STAFF REPORT
COMMUNITY DEVELOPMENT DEPARTMENT

HEARING DATE: 8/12/2021
 TO: Planning & Zoning Commission
 FROM: Joe Dodson, Associate Planner
 208-884-5533
 SUBJECT: H-2021-0046
 Centerville Subdivision

LOCATION: The site is located at 4111 E. Amity Road (including the outparcel to the south) and 5200 S. Hillsdale Avenue, at the southeast corner of S. Hillsdale and E. Amity, in the NW ¼ of the NE ¼ of Section 33, Township 3N., Range 1E.

D. Landscape Plans (date: 6/07/2021)

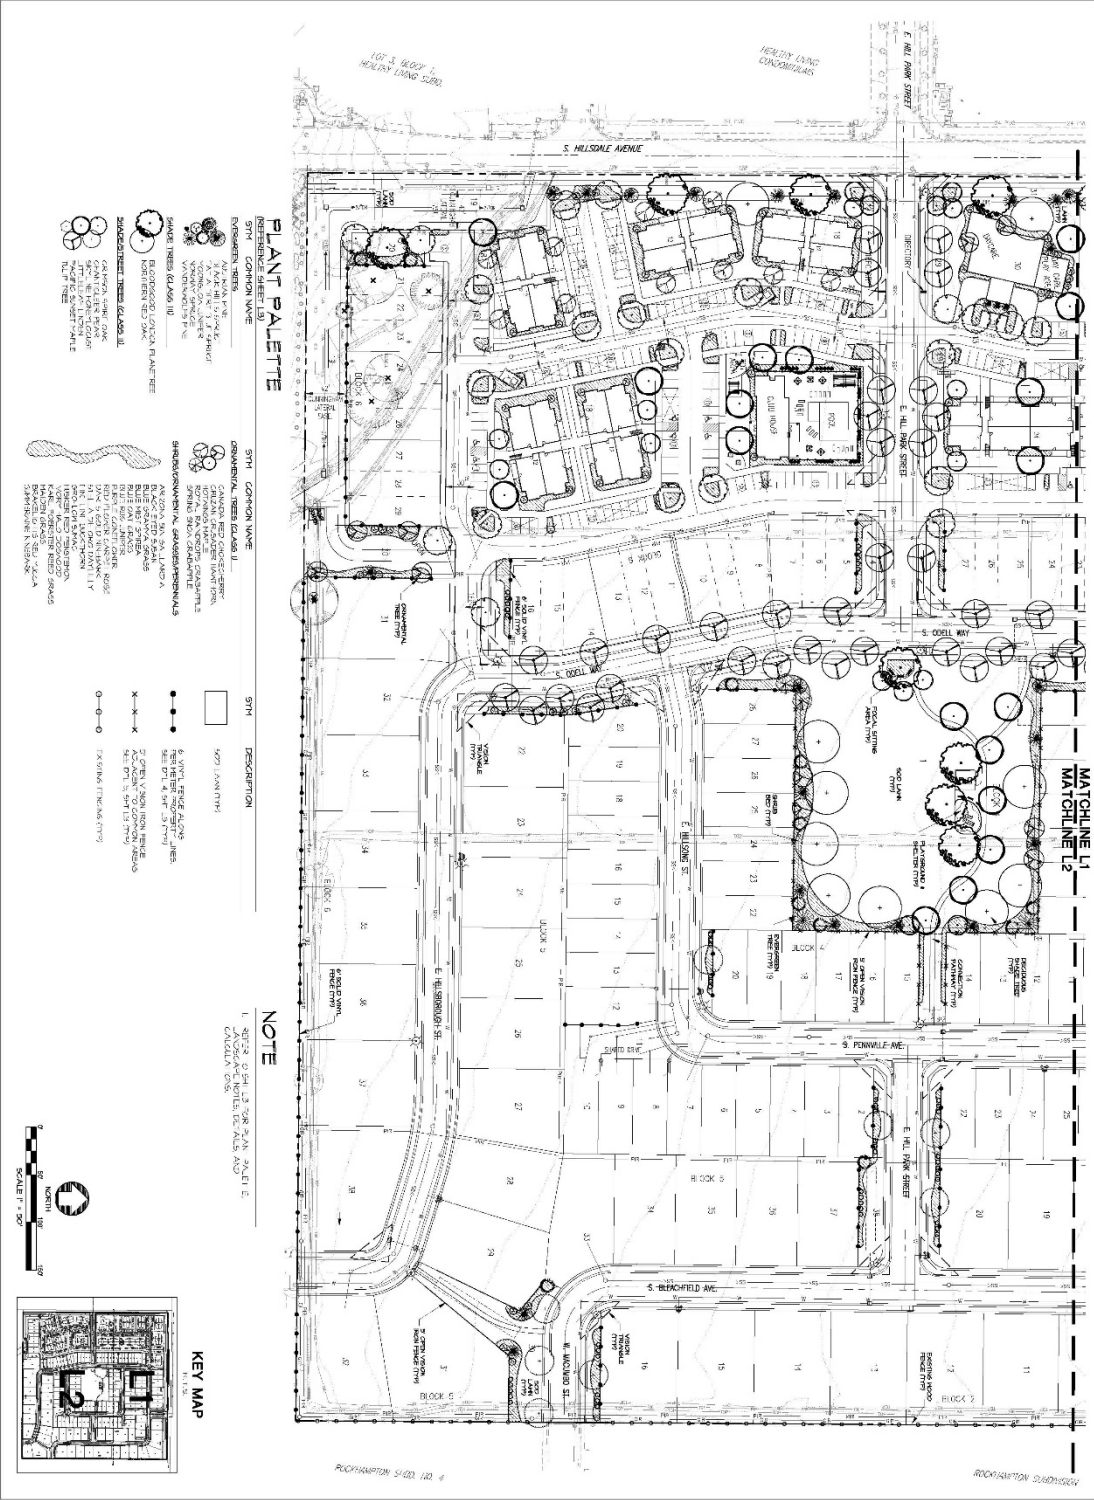
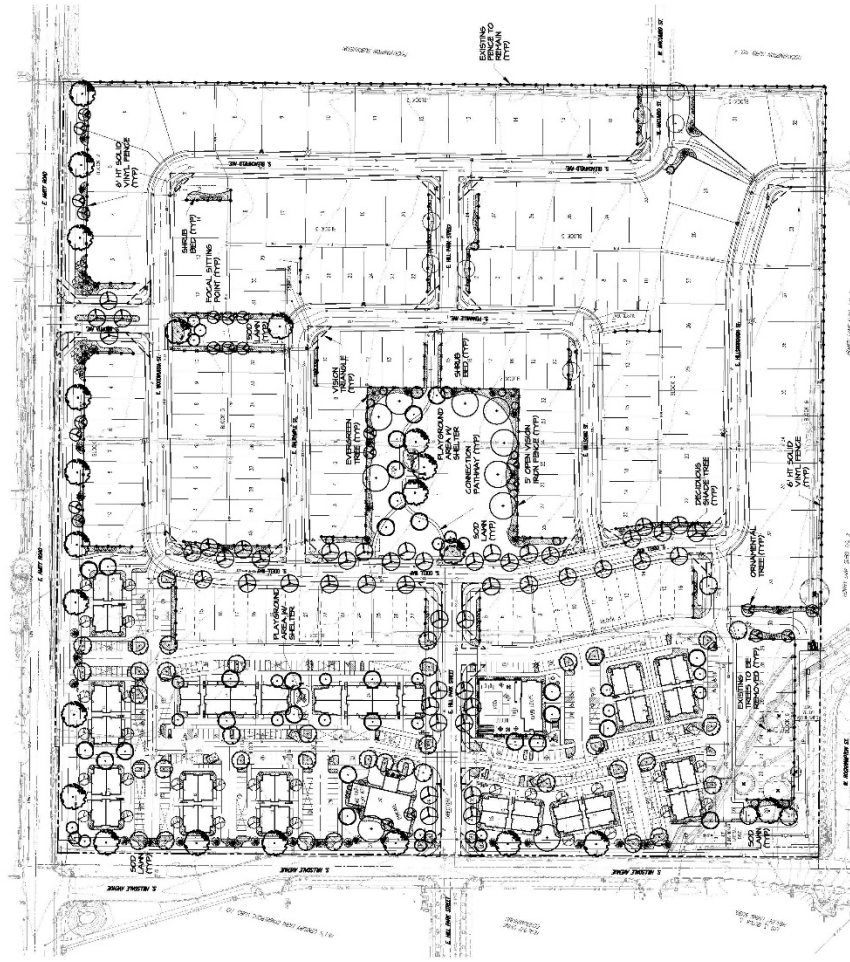
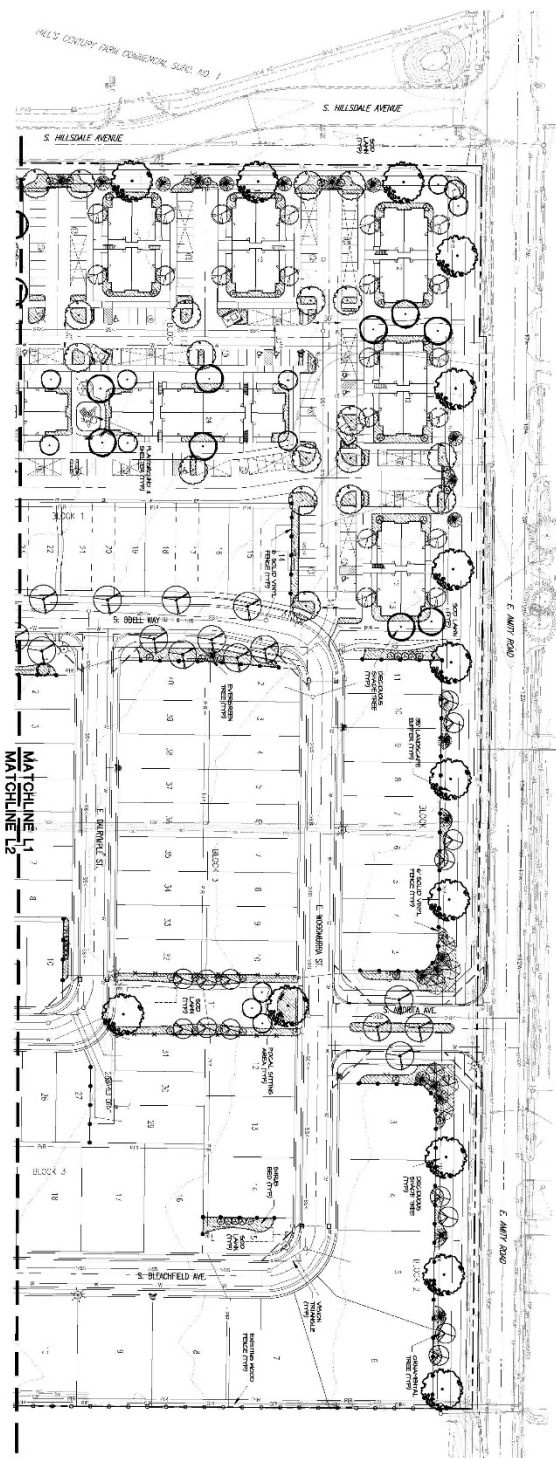
Landscaping is required along all pathways (including micro-pathways) in accord with the standards listed in *UDC 11-3B-12C*. The total lineal feet of *all* pathways with the required and proposed number of trees are not included in the Landscape Calculations table on the submitted landscape plans. This should be corrected prior to Final Plat submittal. However, the correct number of trees appear to be shown on the submitted plans. *The Applicant has proposed a micro-path in the southeast corner of the site to connect two blocks and the correct number of trees is shown on the landscape plans but there are no trees shown adjacent to the pathway to offer any shade. The pathway segment is slight over 100' which requires only one tree adjacent so the Applicant should move one tree from a portion of this common lot and place it next to the pathway to comply with UDC 11-3B-12C.*

3. The landscape plan included in Section VII.D, dated June 7, 2021, shall be revised as follows at least ten (10) days prior to the City Council hearing:

- a. Revise the landscape plans to match the revised preliminary plat;
 - b. Per UDC 11-3B-12C, place at least one tree along the micro-path located on Lot 30, Block 5, as labeled on the revised preliminary plat.
